# Groundwater Transfer Review Summary Form

Transfer/PA # T- 14075

Application: T-14075      Applicant Name: Kameron DeLashmutt / Pinnacle Utilities, LLC

1. Basic description of the changes proposed in this transfer: The applicant proposes to temporarily change the character of use, place of use, and points of appropriation from a 6.3 acres/0.079 cfs portion of certificate 87558 to an equivalent volume of quasi-municipal use on the area coincident with the POU for permit G-17036.

## Review Map

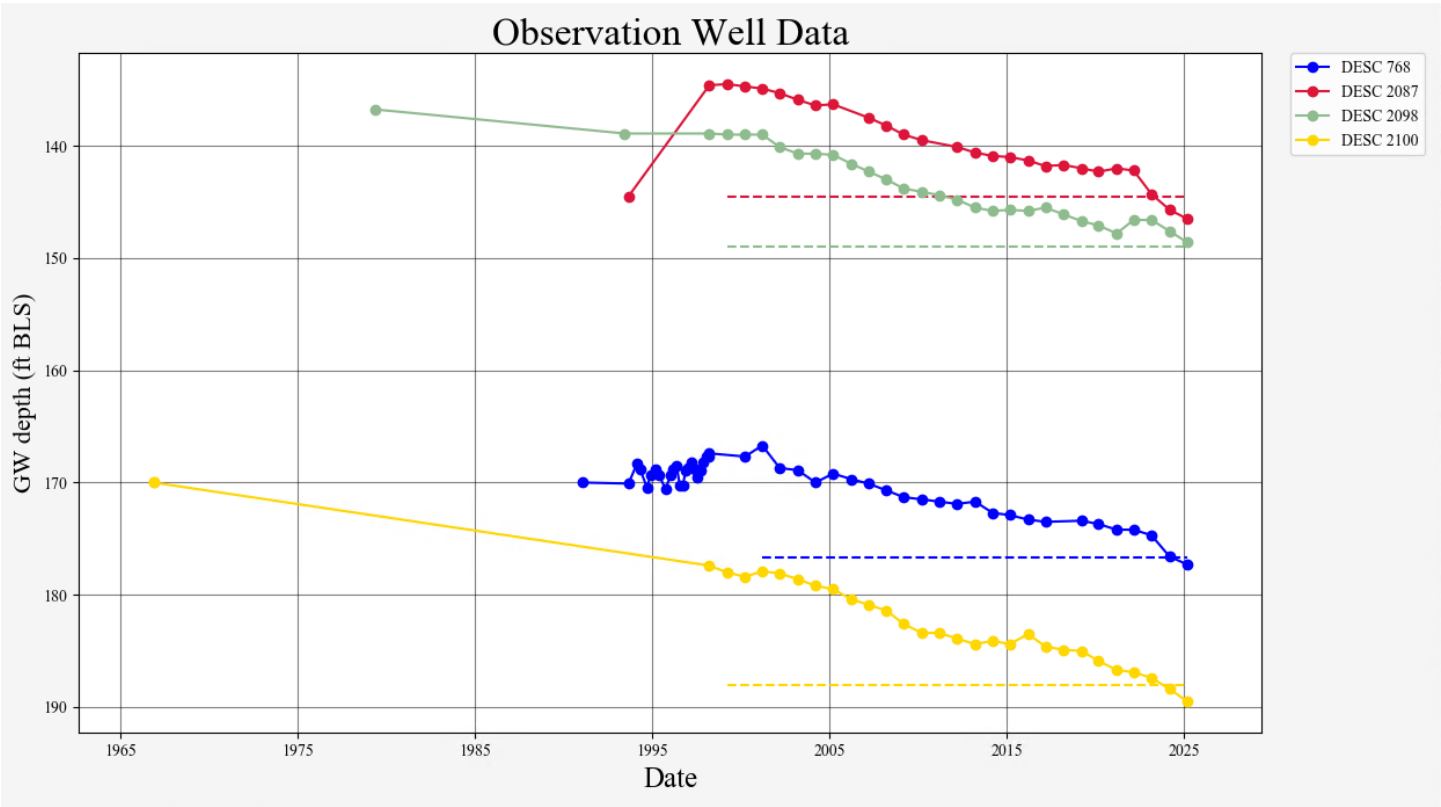
5. a) Will this proposed change, at its maximum allowed rate of use, likely result in an increase in interference with **another ground water right**?  
☒ Yes ☐ No Comments: The proposed changes will move groundwater use from the Lower Bridge area to the Cline Buttes area. This will likely result in an increase in well-to-well interference with adjacent groundwater users in the Cline Buttes area.

6. a) Will this proposed change, at its maximum allowed rate of use, likely result in an increase in interference with **another surface water source**?  
☒ Yes   ☐ No   Comments: The proposed changes will move groundwater use from the Lower Bridge area to the Cline Buttes area. This will likely shift some of the expected capture from the Deschutes River to the Crooked River.
